Request to Modify John Kimbrough Blvd. Pickard Pass

Clint Willis, Manager
Transportation Services
CBE Design Review Committee Meeting
Oct. 28, 2020

TEXAS A&M UNIVERSITY

John Kimbrough Blvd. and Wellborn Rd. Intersection

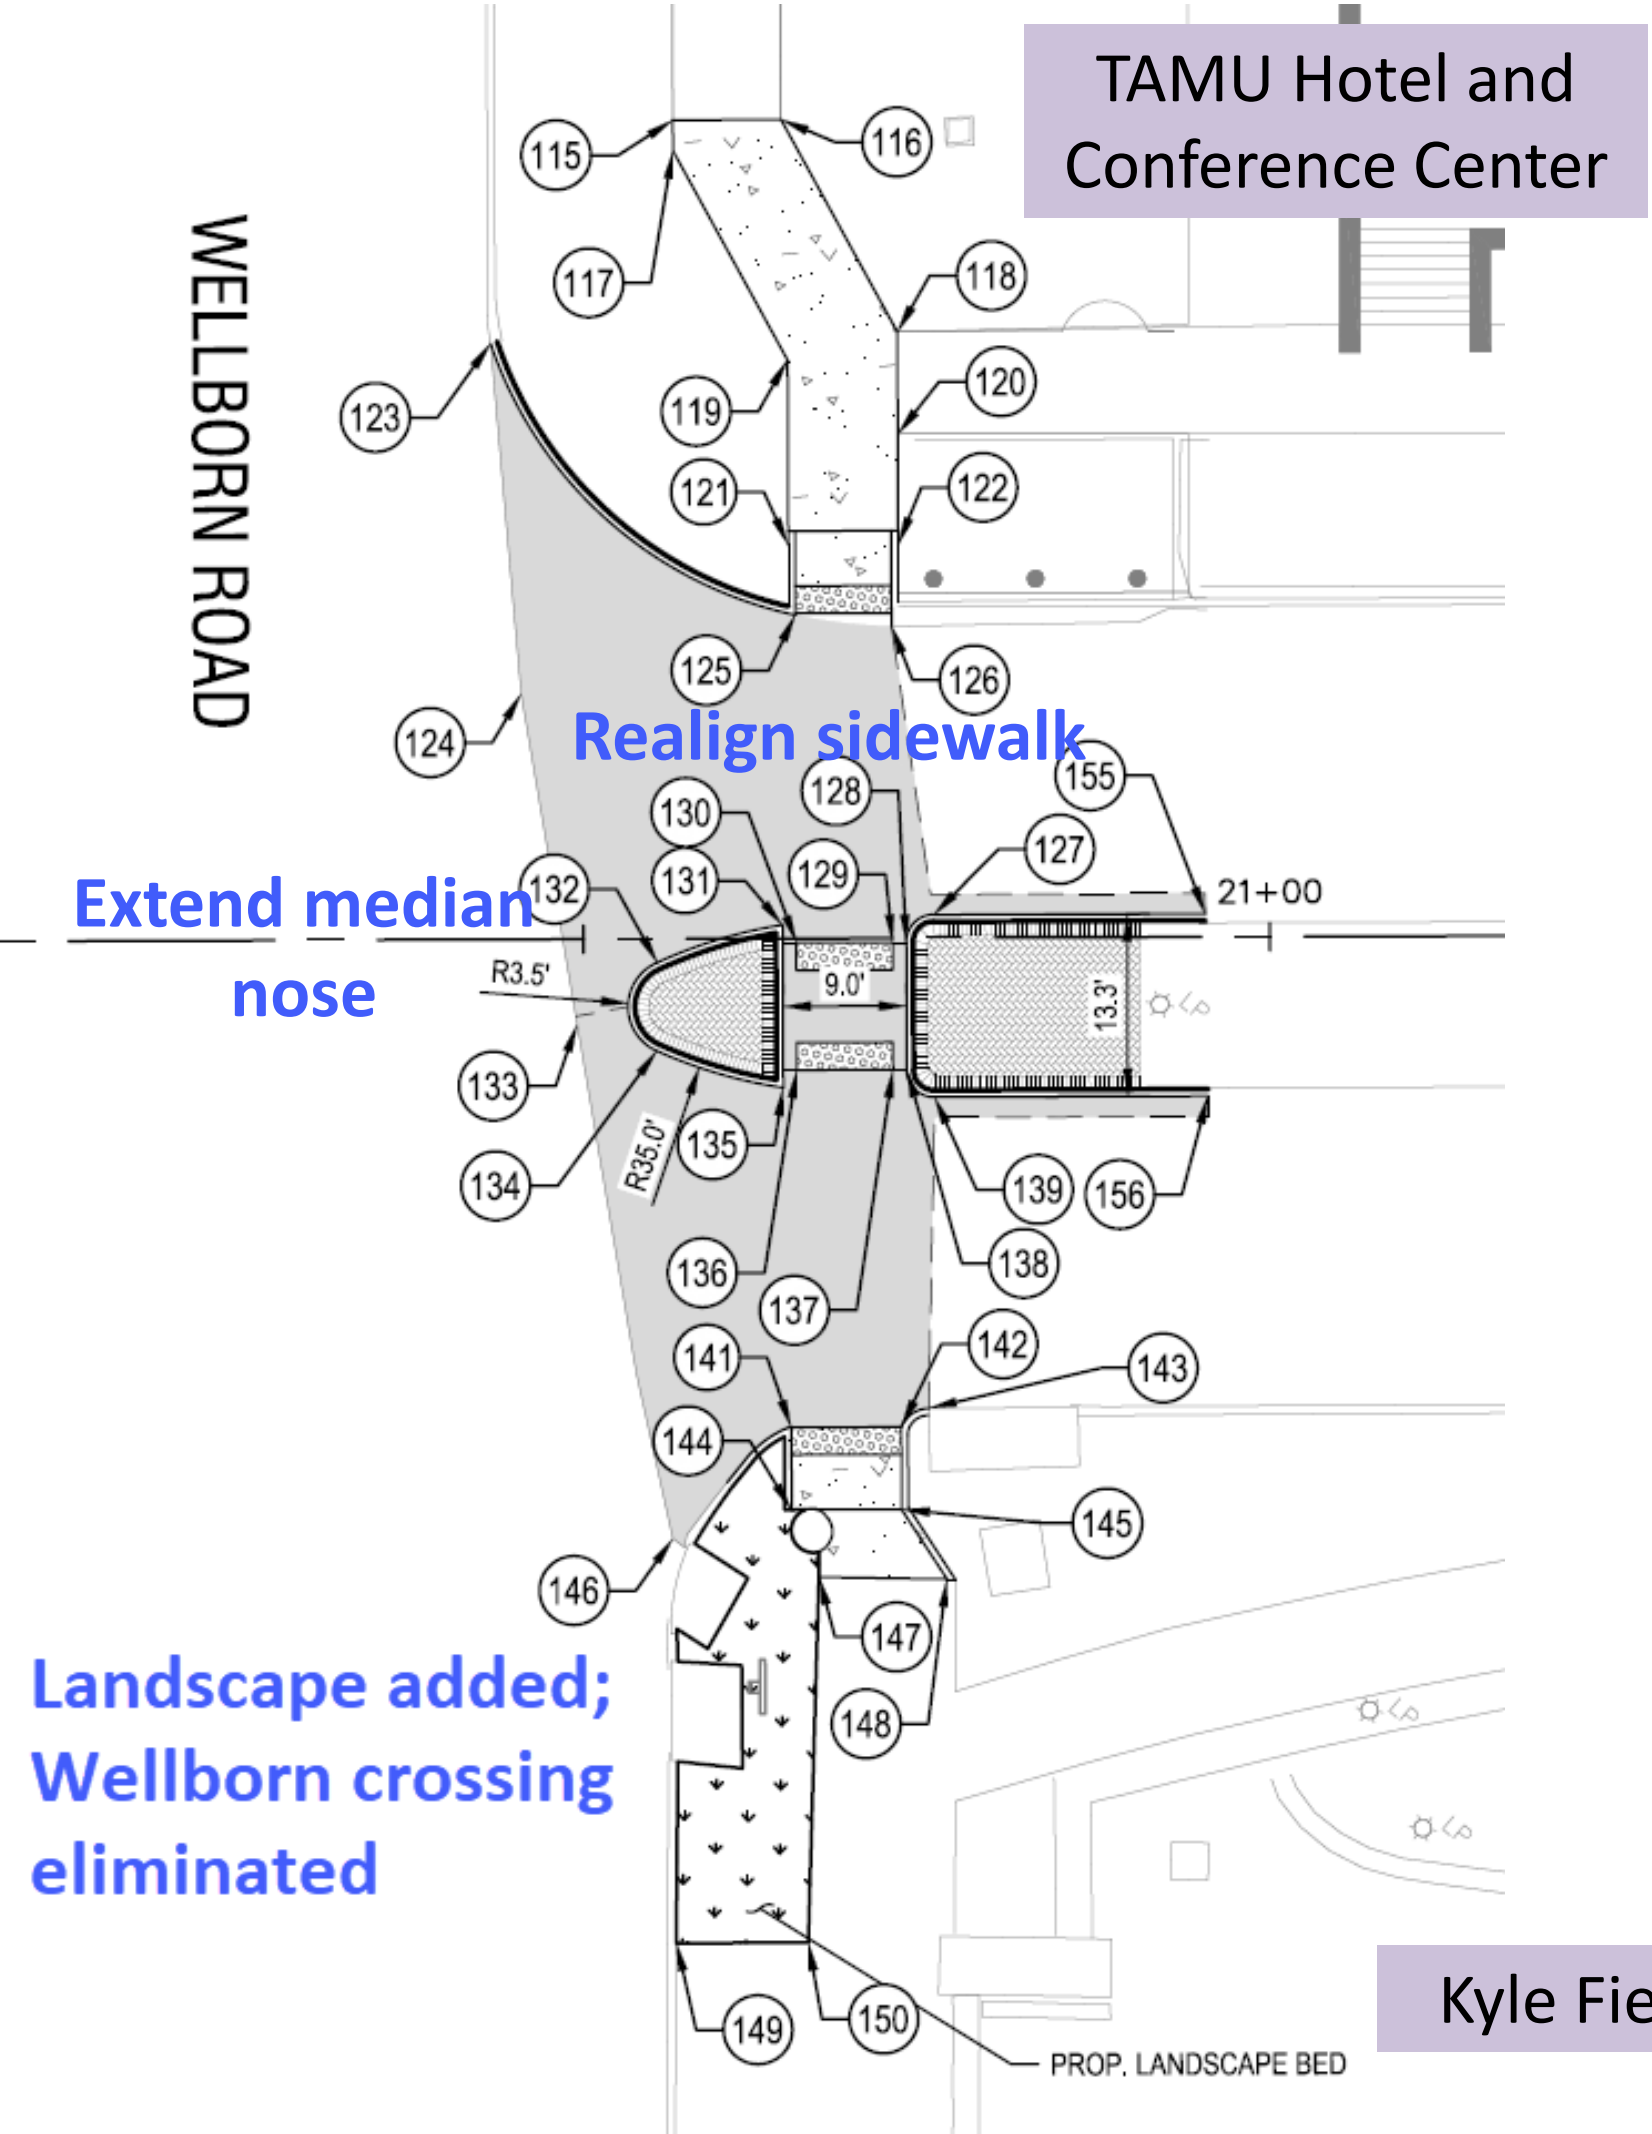
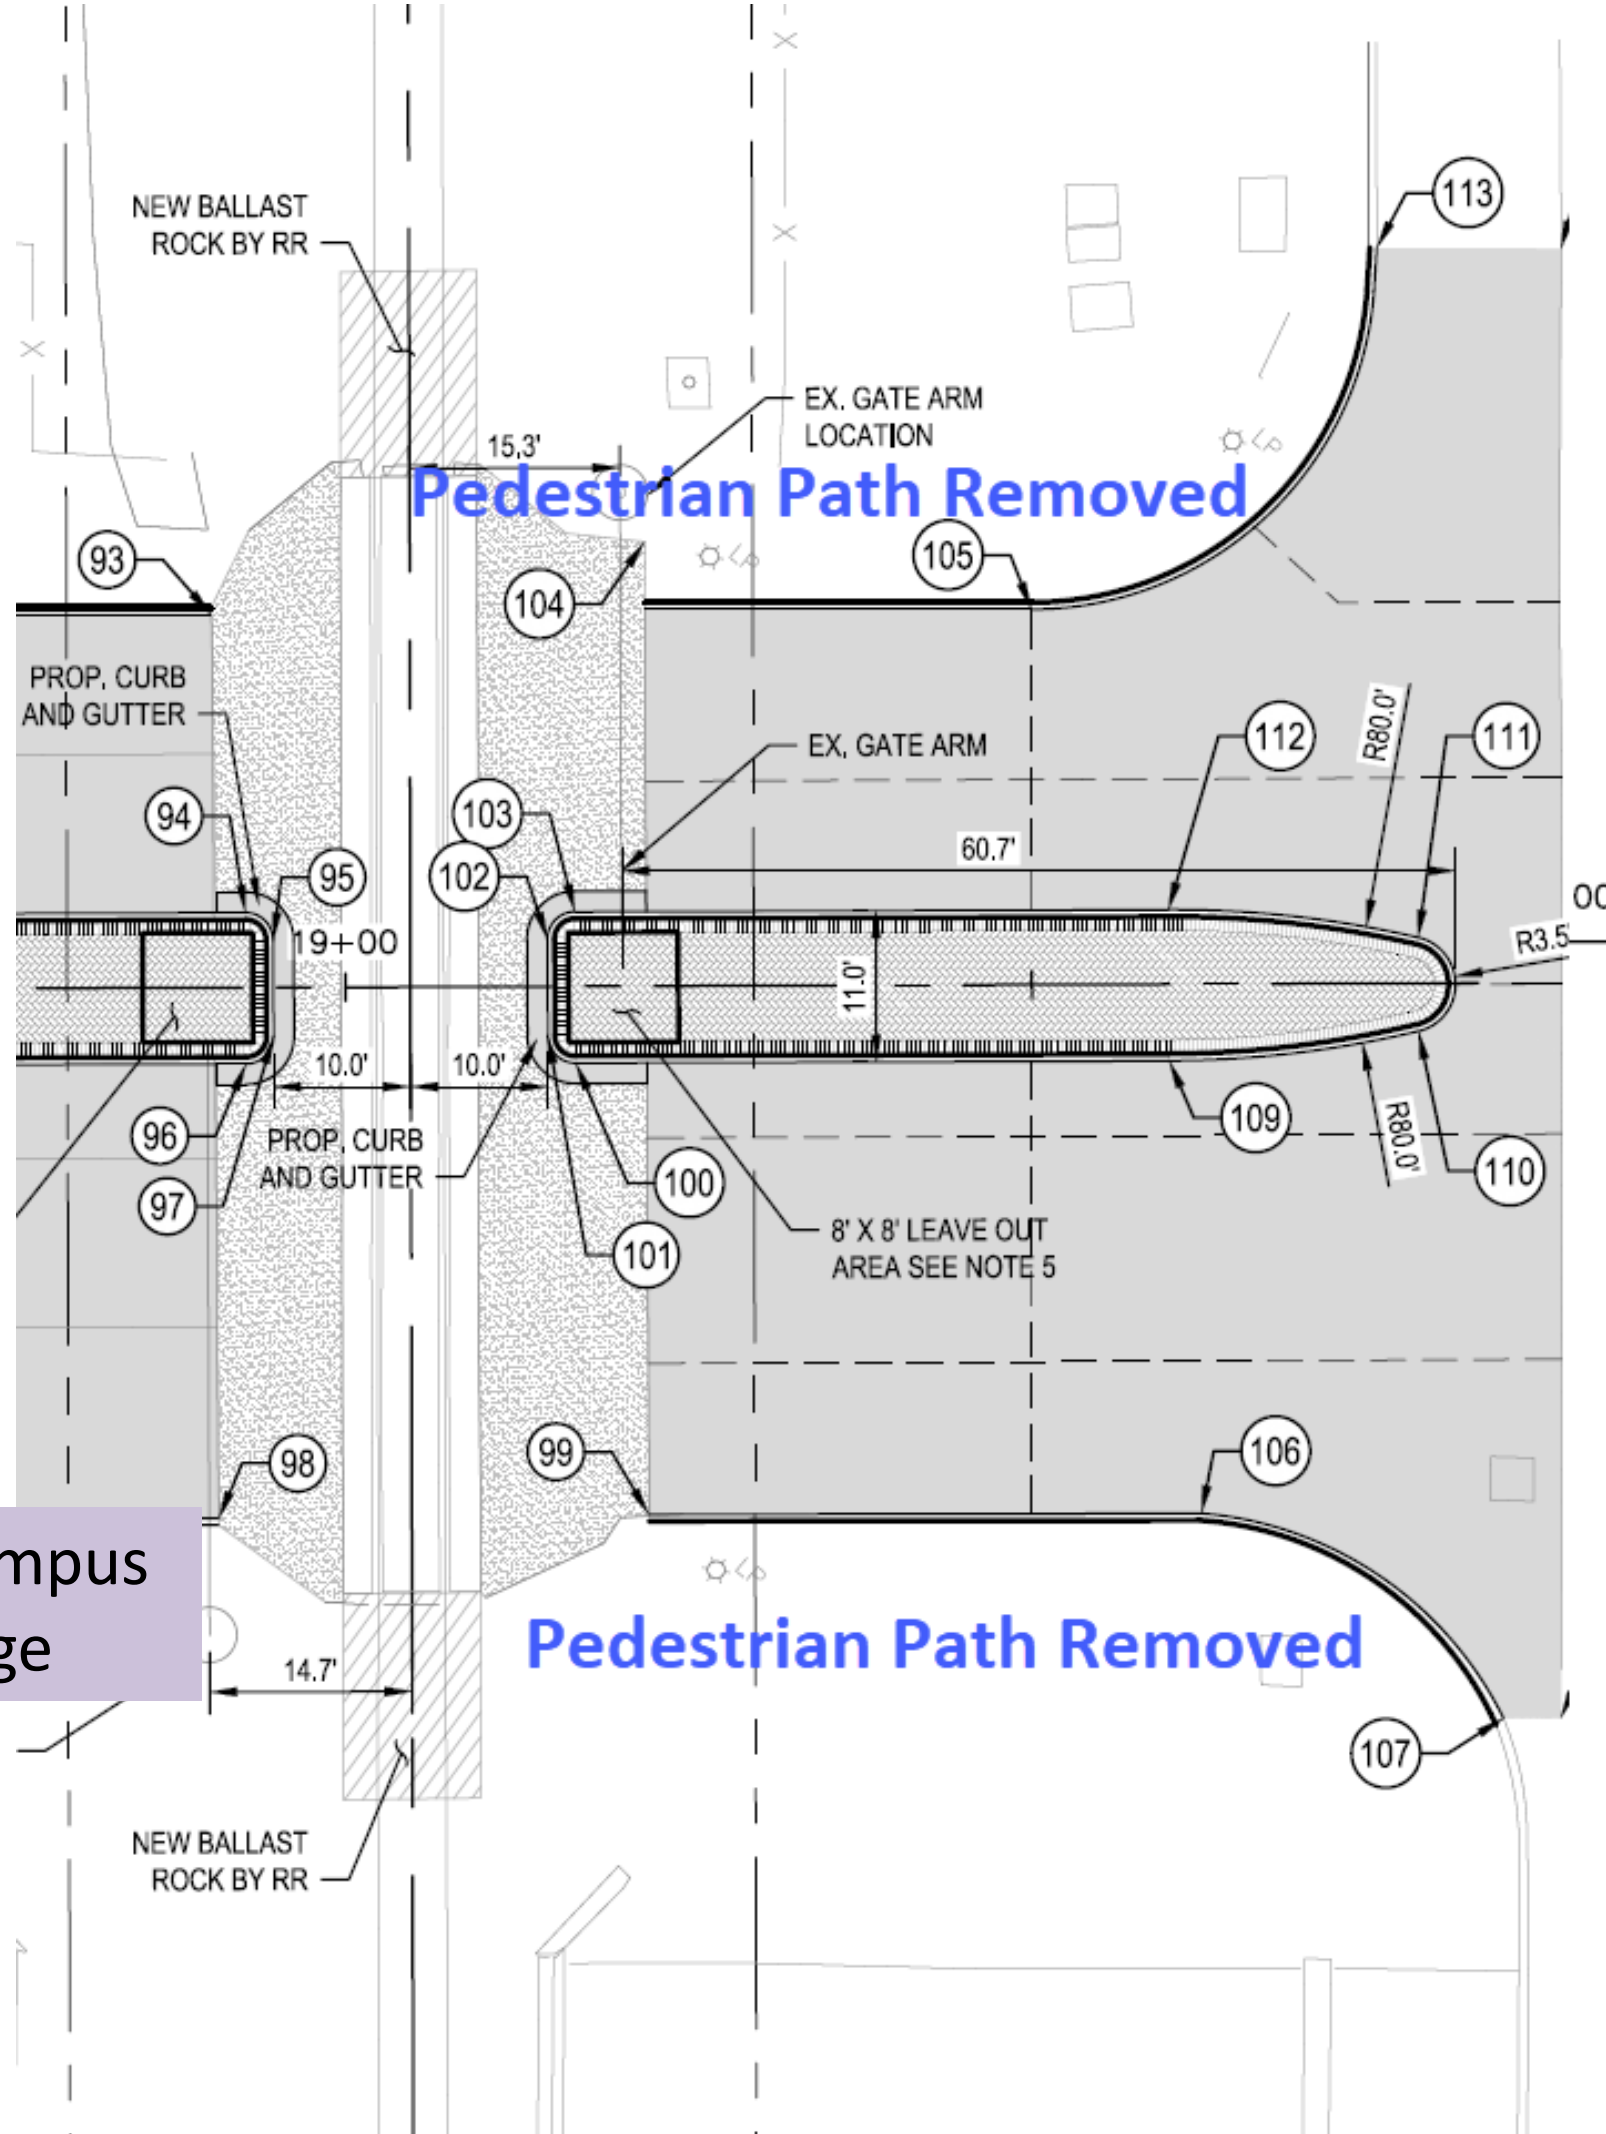
The project realigns this sidewalk and crosswalk and extends the median nosing

The project removes the crosswalk in this image and the pedestrian facilities on the west side of the intersection; extends the landscaping elements to all corners

The project removes this crosswalk and creates a quiet zone compliant median; extends the landscaping elements to all corners

This rendition shows the new landscape elements on all corners, wayfinding signage and the one remaining, realigned north-south crosswalk

Eliminate West Side Passageway Stairs

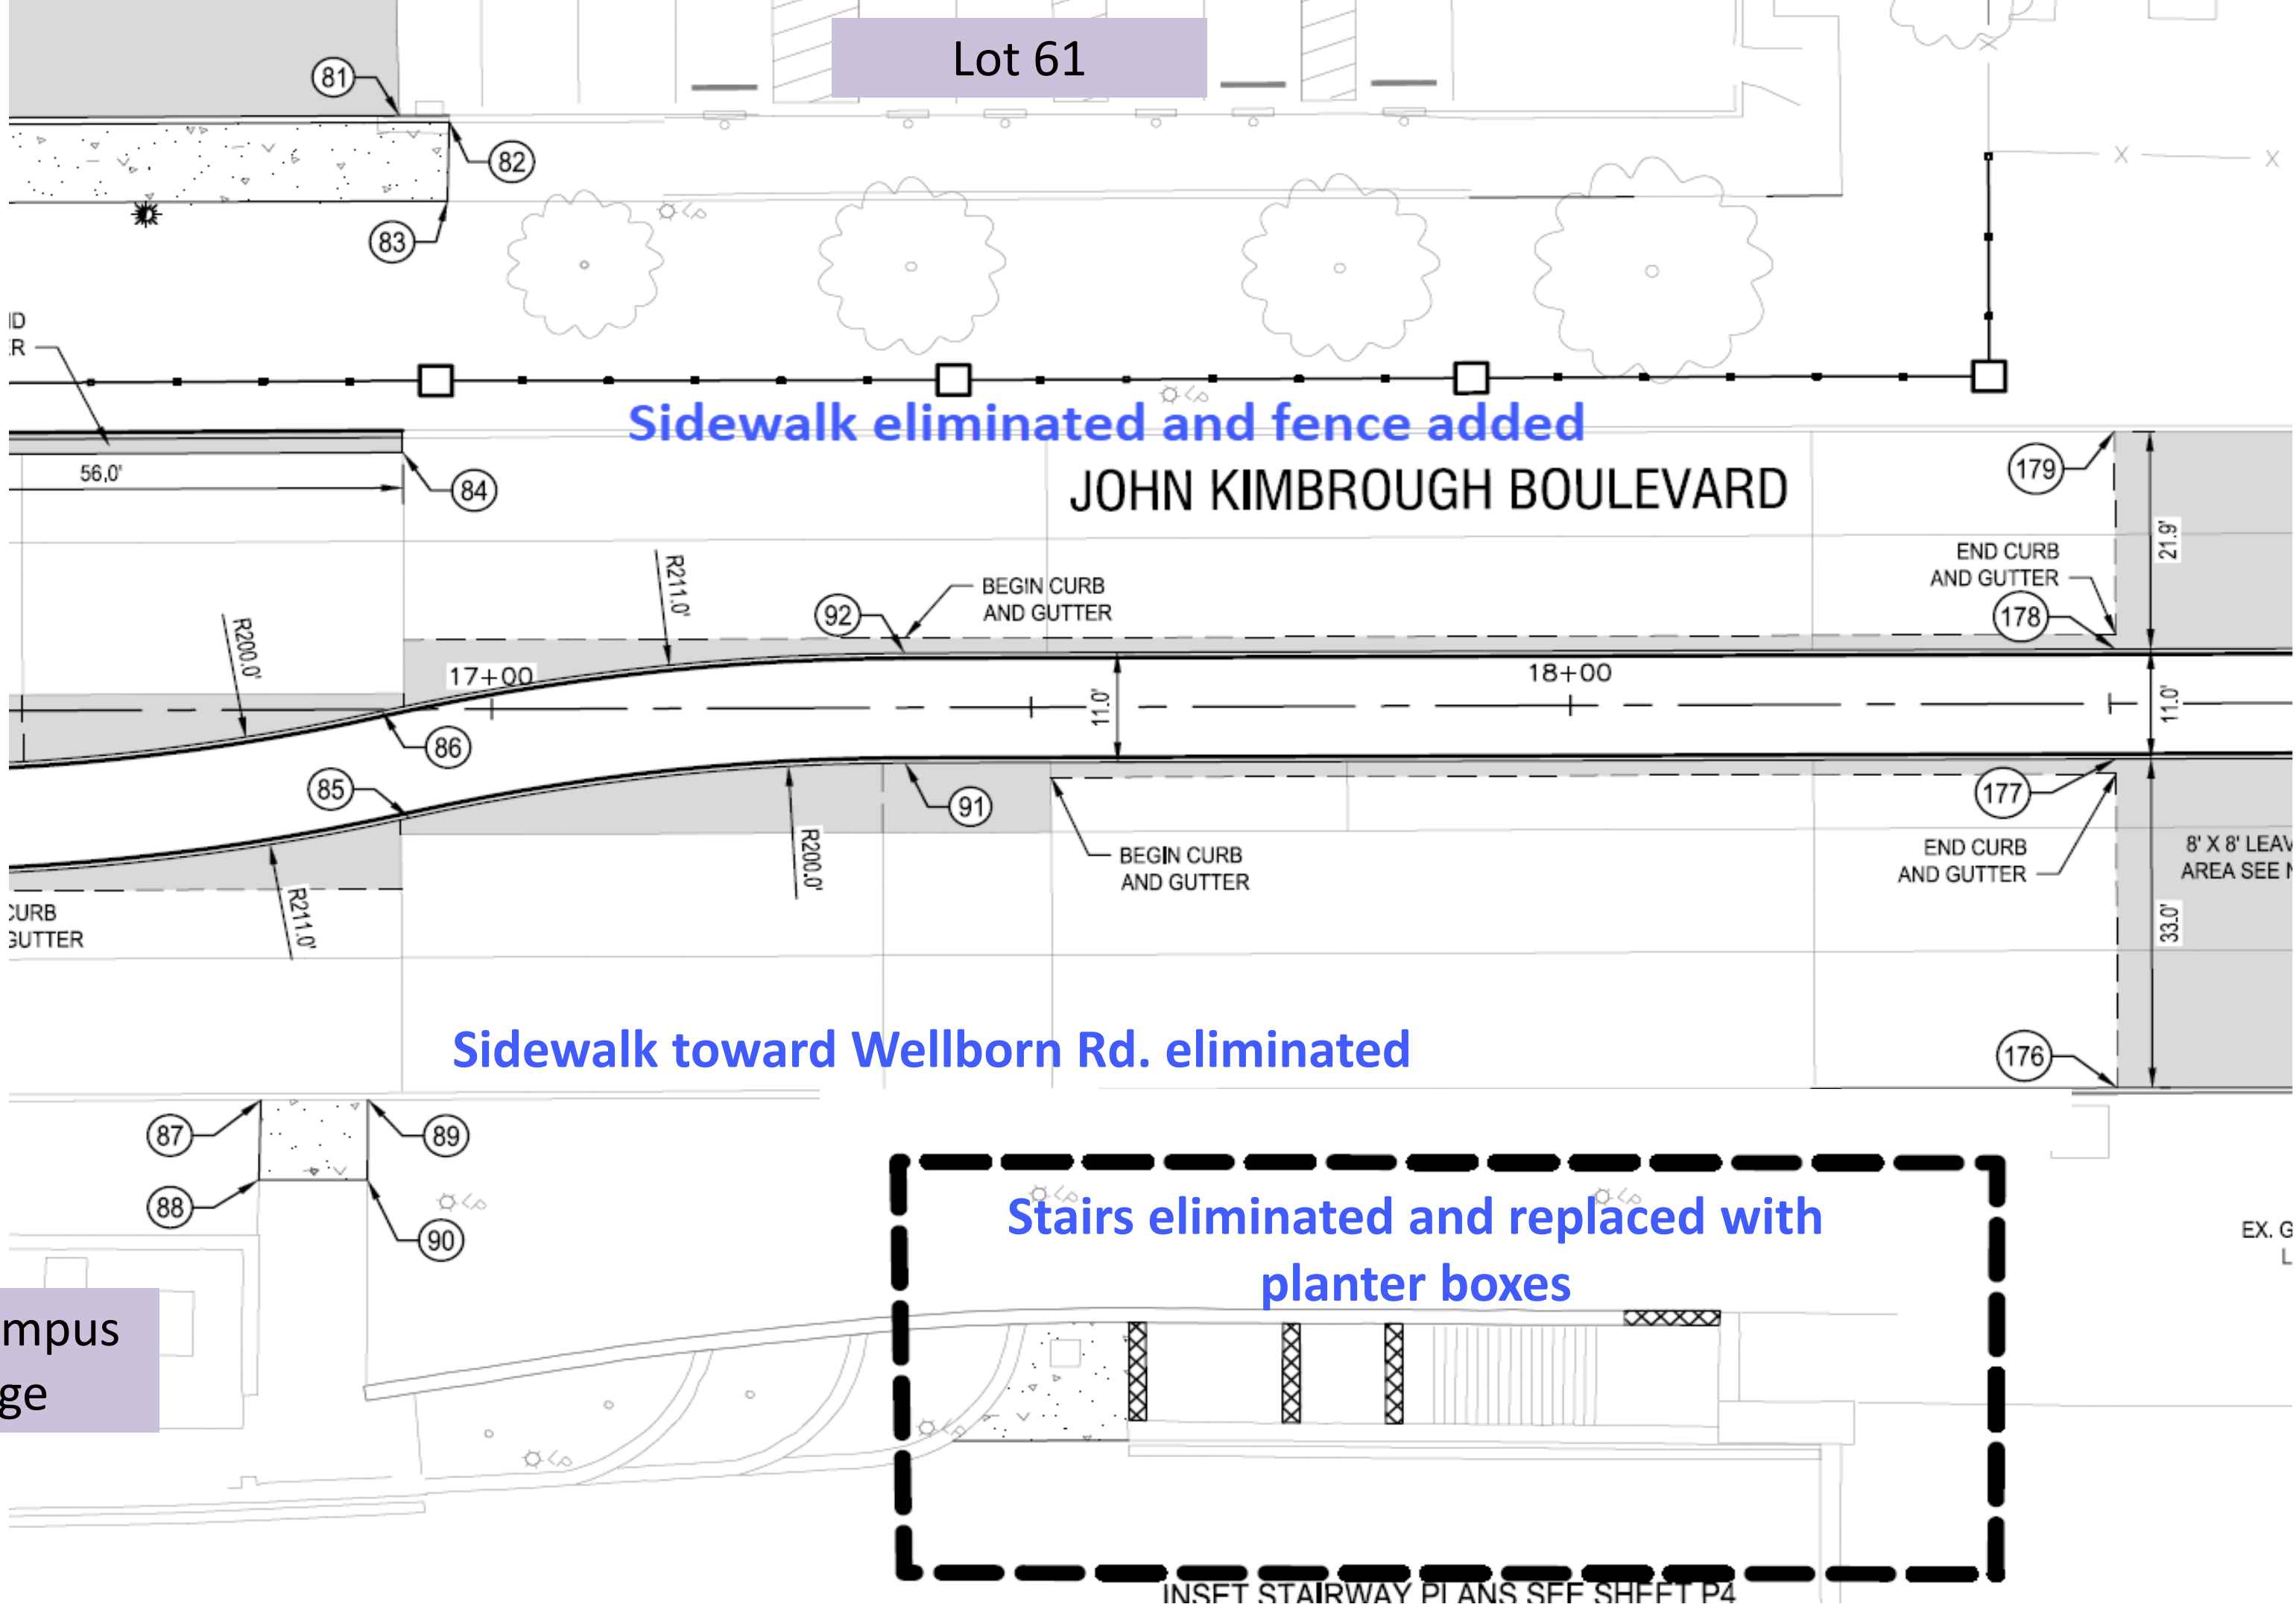
Stairs eliminated and replaced with terraced planters

Sidewalk eliminated and fence added

Sidewalk toward Wellborn Rd. eliminated

Stairs eliminated and replaced with planter boxes
